URGENT Field Safety Notice

Allura Xper, Allura Centron, and Azurion systems
Potential loss of imaging functionality resulting from no or intermittent X-ray radiation initiation through the wired foot switch.

15-August-2023

Reference: 2023-IGT-BST-004: Allura Xper, Allura Centron, and Azurion Systems.

Figure 1: AD7XT and AD7XNT Patient Table

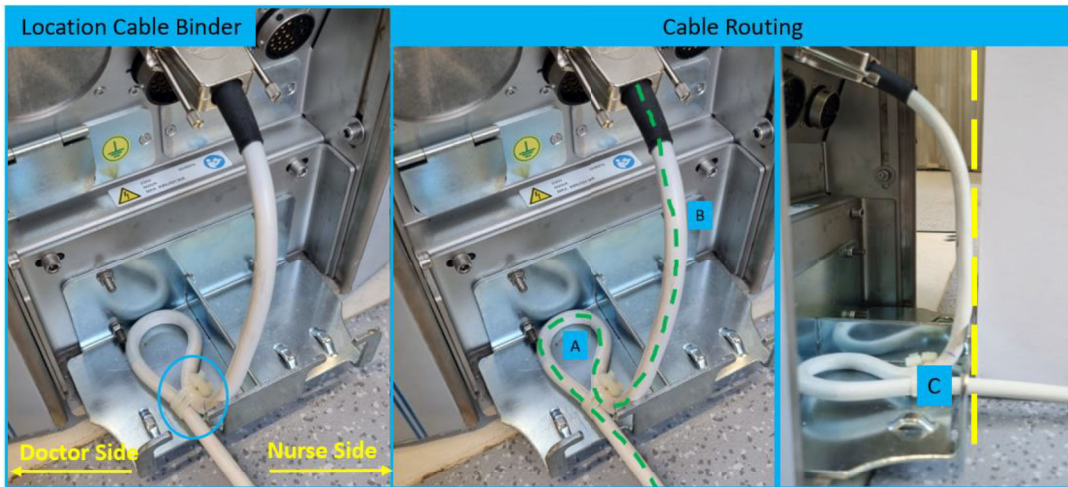
Check the strain relief and routing of the wired foot switch cable:

- Cable binder used for strain relief:
 - Type of cable binder(s)
 - Number of cable binder(s)
 - Position of cable binder(s)
- Cable routing (depending on picture indicated with "A" "B" "C")
- For AD7NT, there are 2 possibilities for strain relief:
 - Strain relief by means of bushing (Figure 4a)
 - Strain relief by cable binder (Figure 4b)
- For correct routing and strain relief, see Figures 1-6 below.

Number of cable binder(s): 2 (two)

If strain relief or routing is not correct, repair according to the repair instructions.

Figure 2: AD7XT and AD7XNT Auxiliary OP Rail Patient Table Strain Relief

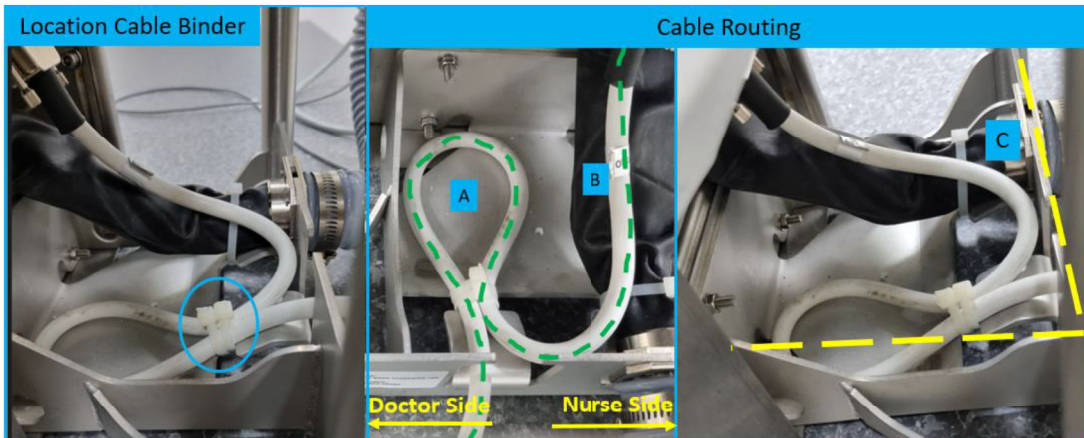
Number of cable binder(s): 2 (two)

Figure 3: AD7 Patient Table

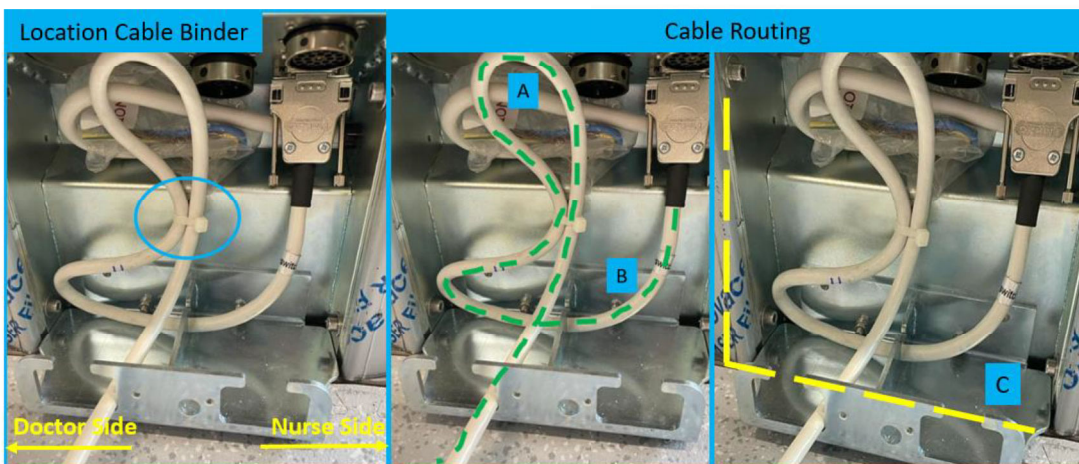
Number of cable binder(s): 1 (one)

Figure 4b: AD7NT Patient Table with cable tie strain relief

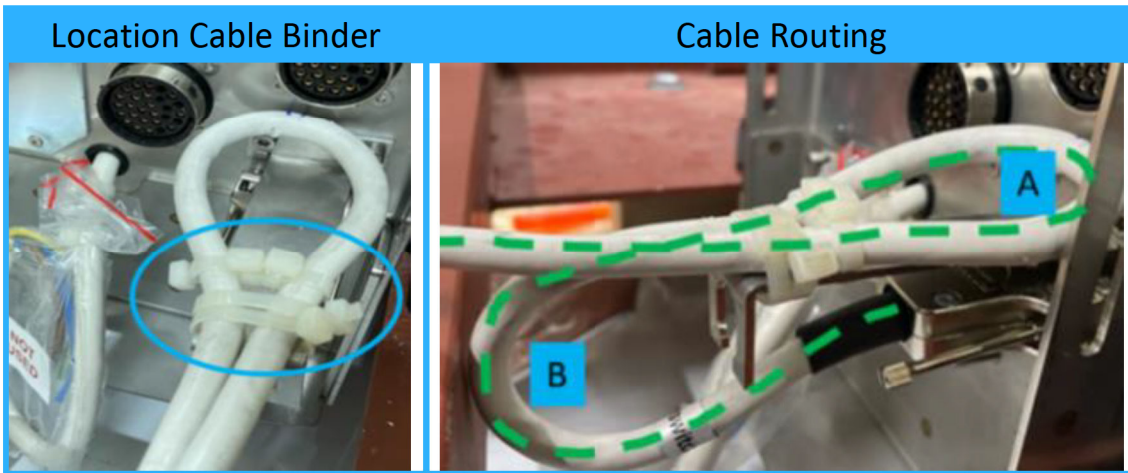
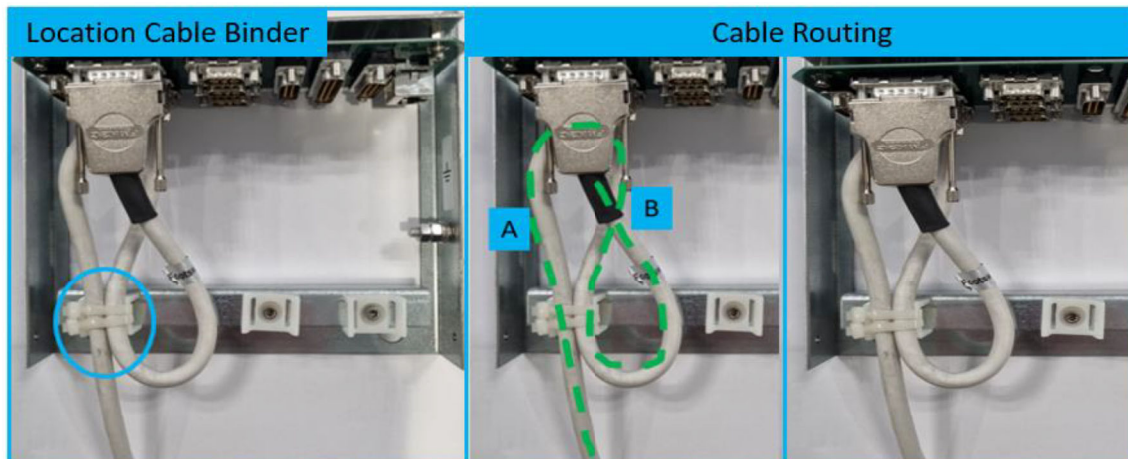
Number of cable binder(s): 5 (five)

Figure 6: Surgery Wall Connection Box

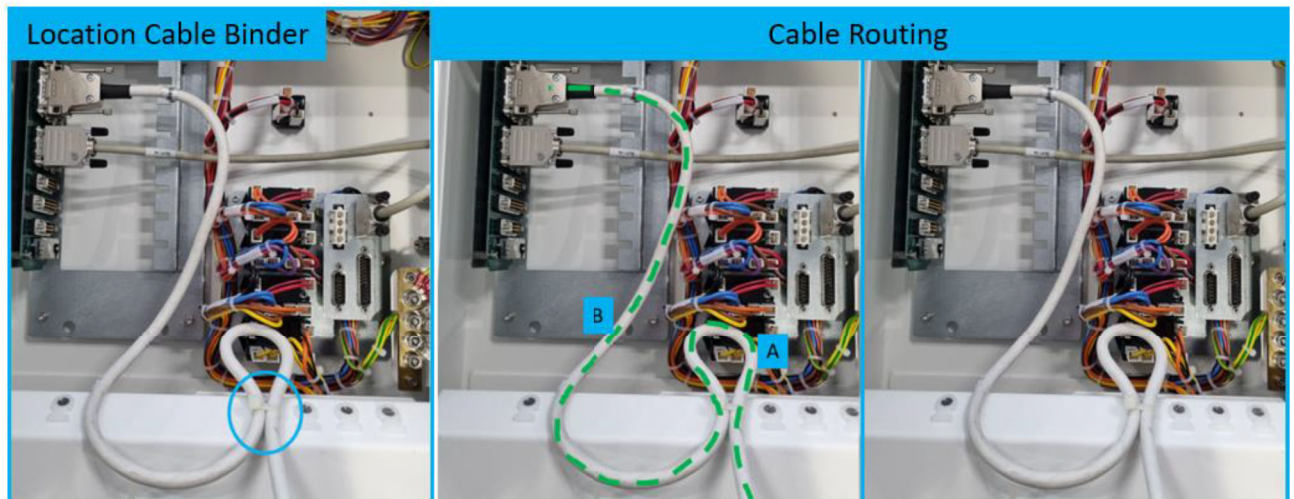
Number of cable binder(s): 1 (one)

Figure 7: Non-swivel table (AD7NT, AD7XT and AD7XNT)

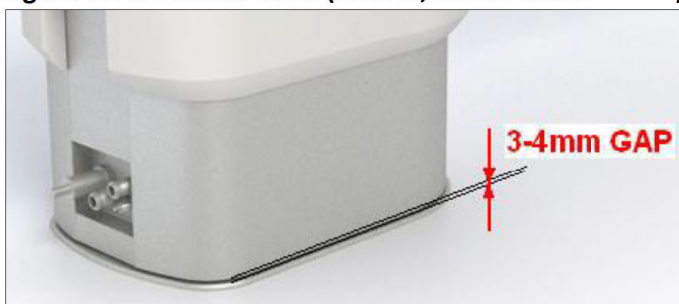
Check the clearance of the plinth cover:

- For a non-swivel table
 - Make sure that the clearance to the fluid protection plate is 3-4 mm
 - Refer to Figure 7
- For a swivel table
 - Make sure that the clearance to the swivel cover is 3-4 mm
 - Refer to Figure 8

If the gap between the plinth covers and the floor does not satisfy the above requirement, adjust the plinth cover according to the repair instructions.
